Access Compliance Report

Public Rights-of-Way

Intersection ID: 49560	Main Street: SPENCER_ST	Cross Street: WARREN_BURGESS_LN	Location: NW
ADA ID: 3344AE667877	Ramp Type: BlendTrans2	Initial Pass/Fail: Fail	Overall Compliance: No
		Severity Score: 1.25

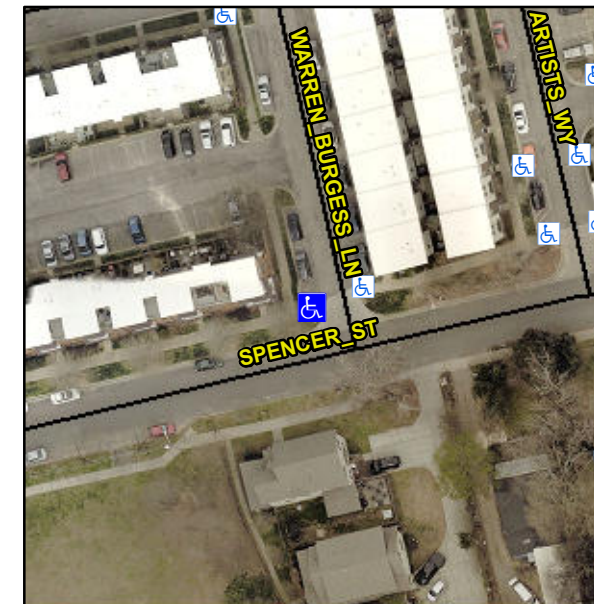
R304.5.3

Compliance	Description	Data	Compliance	Description	Data
N/A	Ramp Length (in)	59.0	Yes	BlendTrans Slope (%)	2.0
Yes	Ramp Width (in)	70.0	No	BlendTrans XSlope (%)	2.2
N/A	Flare Type LT	N/A	N/A	Flare Type RT	N/A
N/A	Flare Slope LT (%)	N/A	N/A	Flare Slope RT (%)	N/A
N/A	Flare Traversable LT?	N/A	N/A	Flare Traversable RT?	N/A
N/A	Landing Length (in)	N/A	N/A	DWS Provided?	No
N/A	Landing Width (in)	N/A	N/A	DWS Contrast?	N/A
N/A	Landing Slope (%)	N/A	N/A	DWS Length (in)	N/A
N/A	Landing X Slope (%)	N/A	N/A	DWS Full Width?	N/A
N/A	Landing Curb? (Y/N)	N/A	N/A	DWS Offset (in)	N/A
N/A	Shared Landing?	N/A			
N/A	Gutter Ponding?	No	N/A	Gutter Slope (%)	0.5
N/A	Gutter Lip Ht (in)	0.0	N/A	Gutter X Slope (%)	2.6
N/A	Painted X Walk1?	Yes	N/A	Painted X Walk2?	N/A
	X Walk 1 Direction	To E		X Walk 2 Direction	N/A
	X Walk 1 Width (in)	60.0		X Walk 2 Width (in)	N/A
	X Walk 1 Slope (%)	1.6		X Walk 2 Slope (%)	N/A
	X Walk 1 X Slope (%)	1.2		X Walk 2 X Slope (%)	N/A

Remove & Replace Curb Ramp With Two New Directional Ramps or Equivalent.
